RHODE ISLAND DEPARTMENT OF TRANSPORTATION

RHODE ISLAND CONTRACT NO.2019-CB-027

Bridge Group 51A - Rt 37 C-2

ADDENDUM NO. 4 Prospective bidders and all concerned are hereby notified of the following changes in the Plans, Specifications, Proposal and Distribution of Quantities for this contract. These changes shall be incorporated in the Plans, Specifications, Proposal and Distribution of Quantities, and shall become an integral part of the Contract Documents.

0013C_V5_007_TYPICAL TRANSVERSE SECTIONS & PROFILE - BRIDGE 062801_R-1.dwg Plotted on Tuesday, October 29, 2019 9:47:47 AM

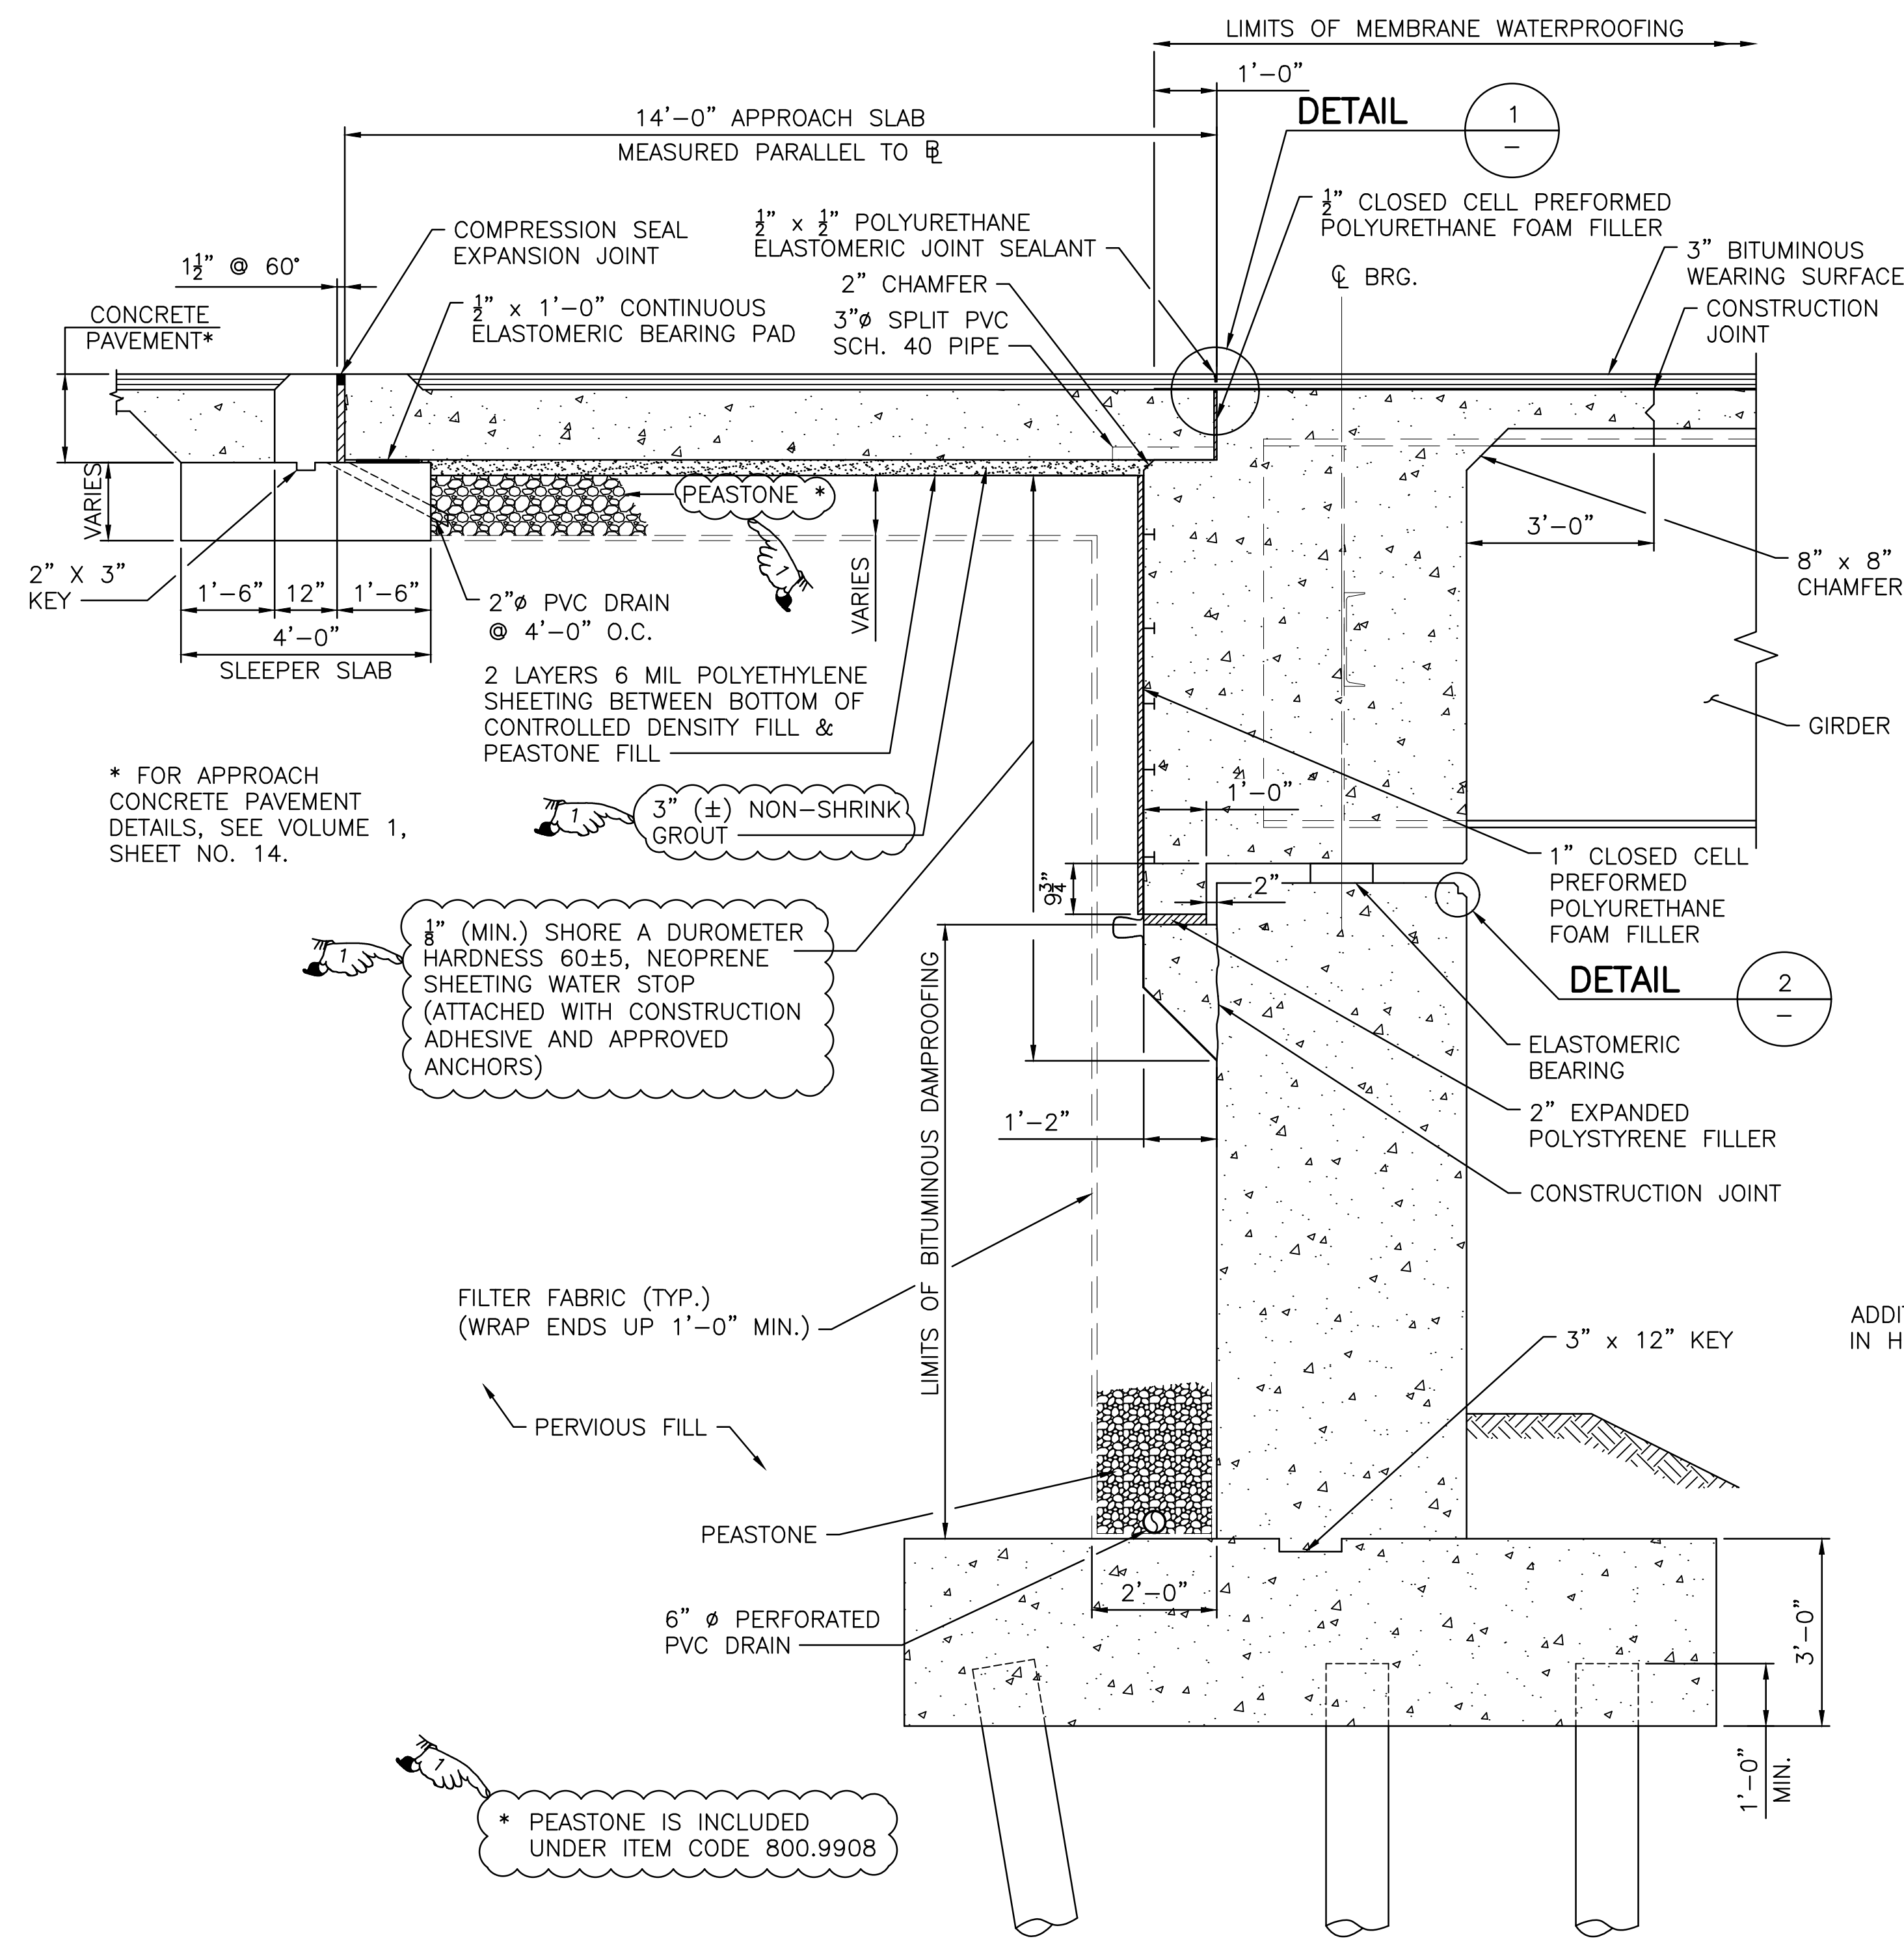
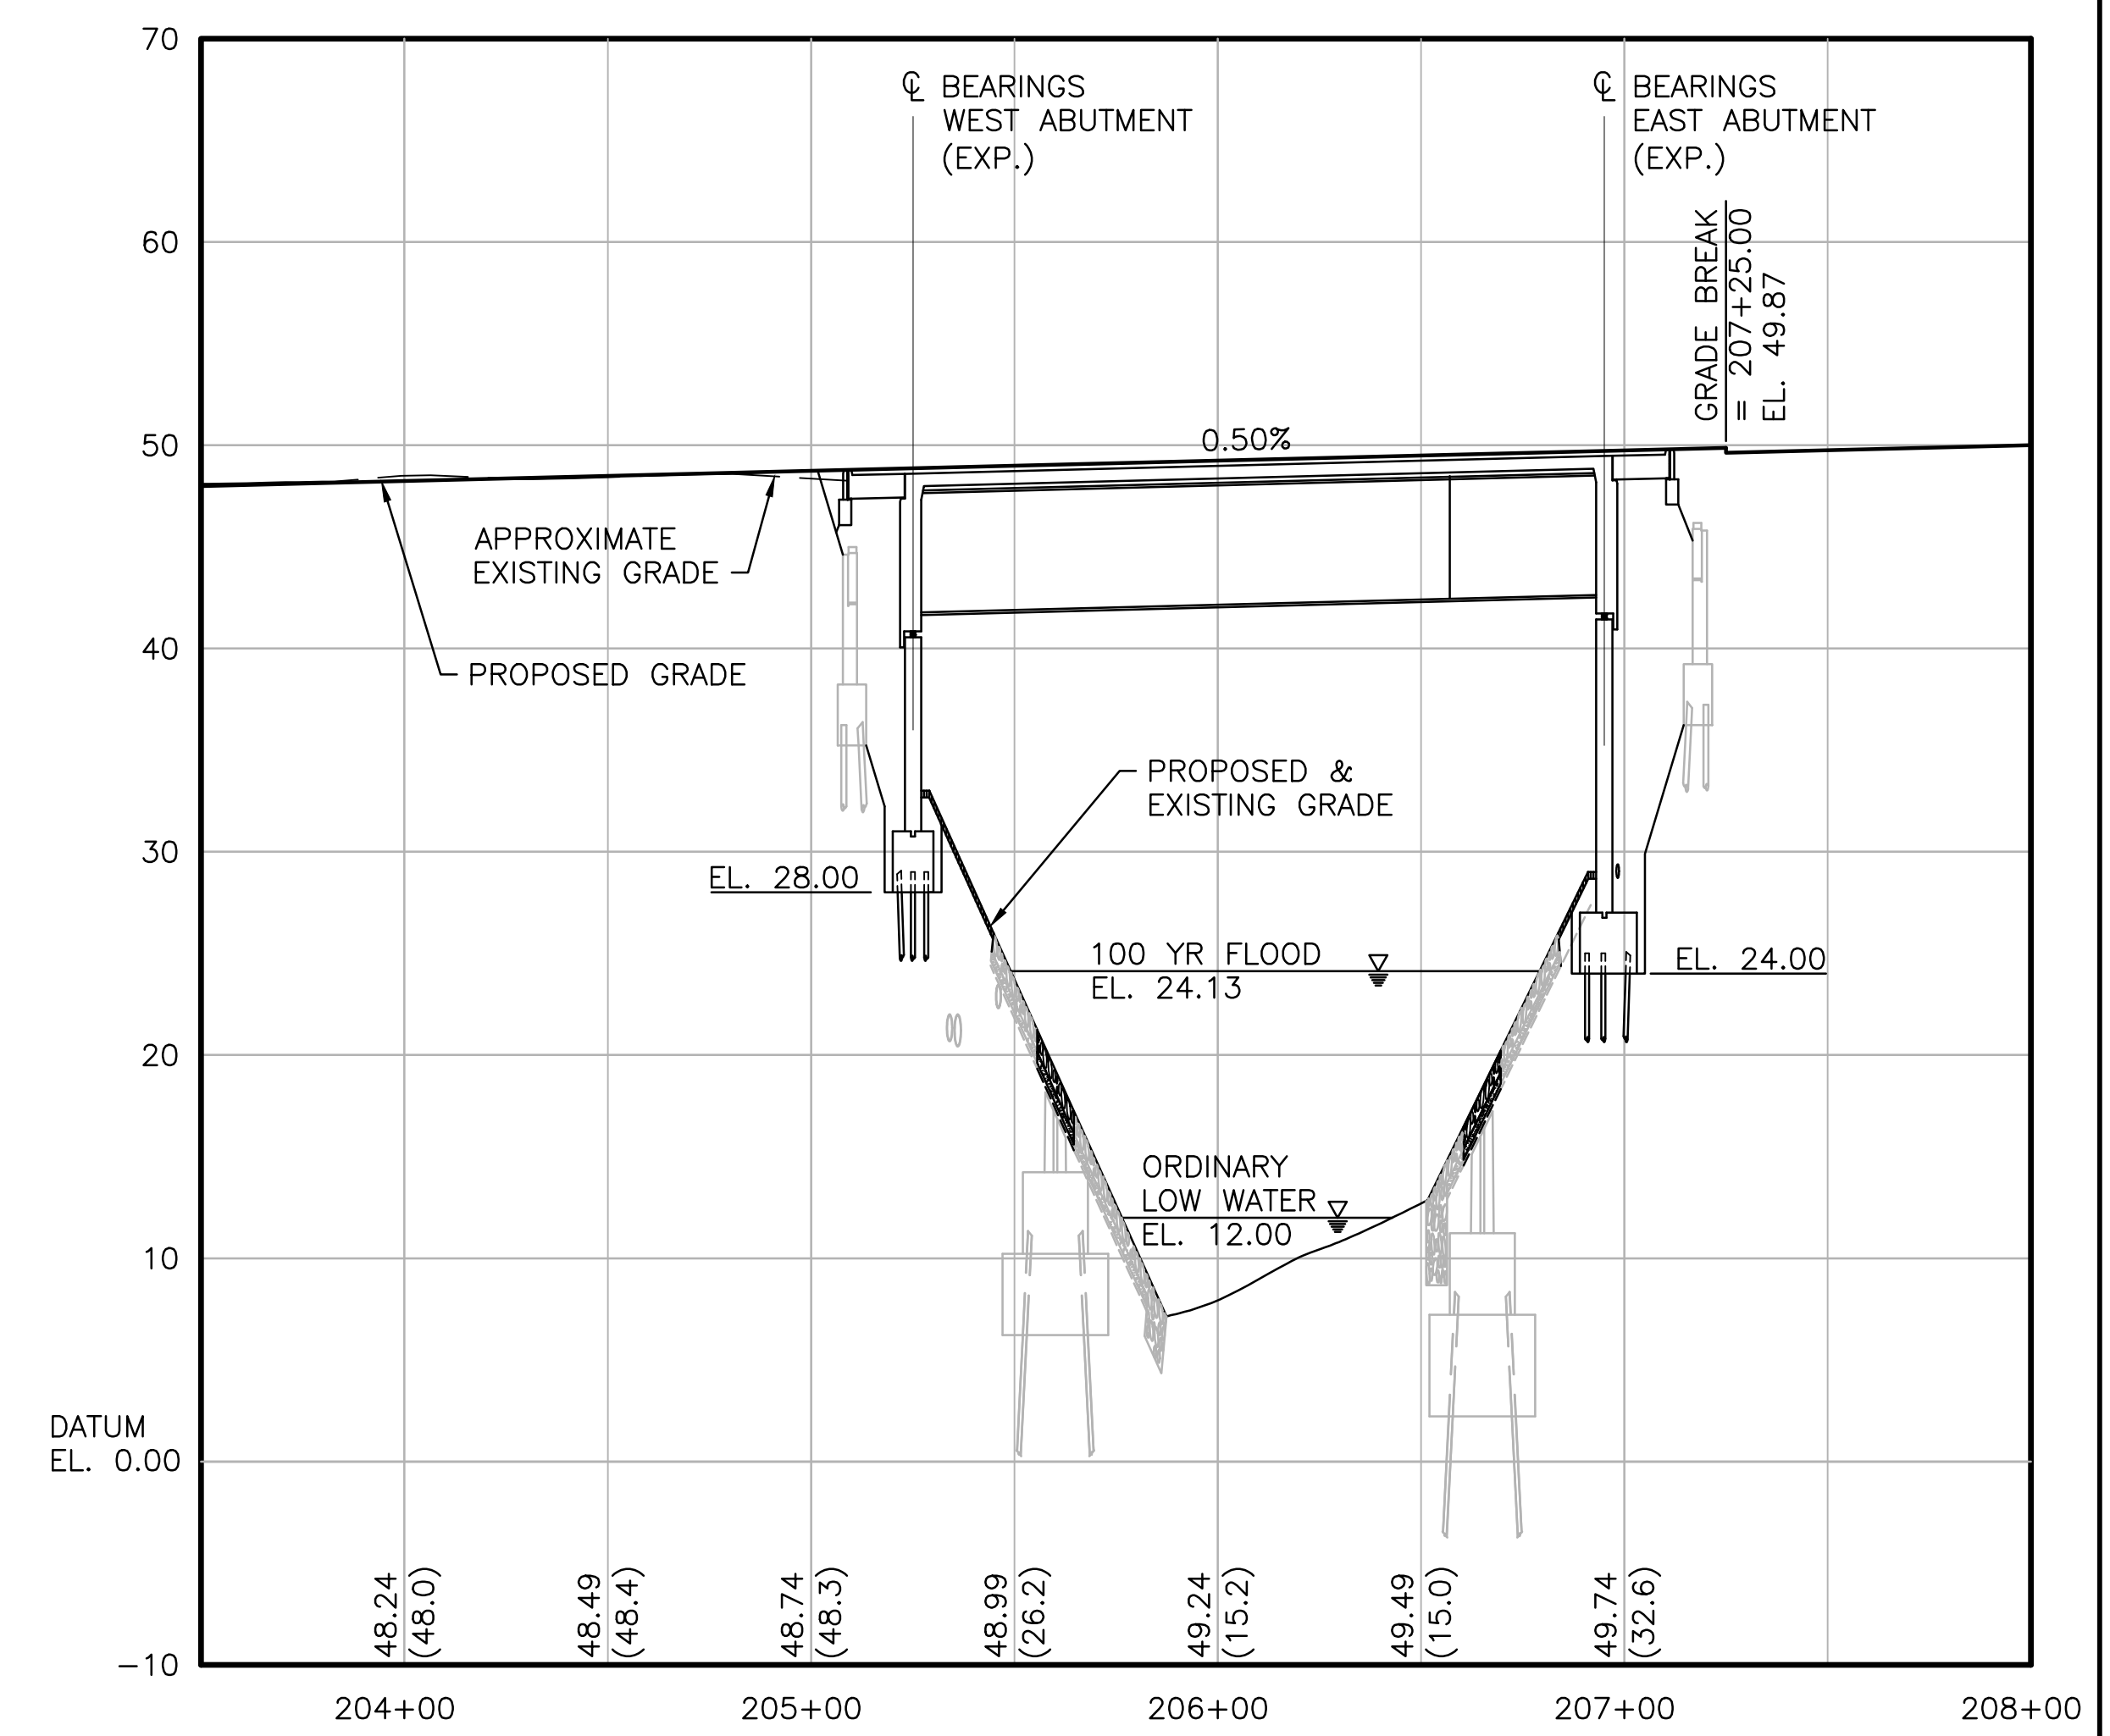
Delete plan sheets 6, 7, 24, 35, 37, 41, 48, 49, 64, 74, 75 in their entirety and replace them with Sheets 6 (R-1), 7 (R-1), 24 (R-1), 35 (R-1), 37 (R-1), 41 (R-1), 48 (R-1), 49 (R-1), 64 (R-1), 74 (R-1), 75 (R-1) attached to this Addendum No. 4. Various notes and callouts have been added or revised to clarify pay items and address other questions raised by bidders. In addition, the HMA wearing surface on the bridge deck and approach slabs has been revised.
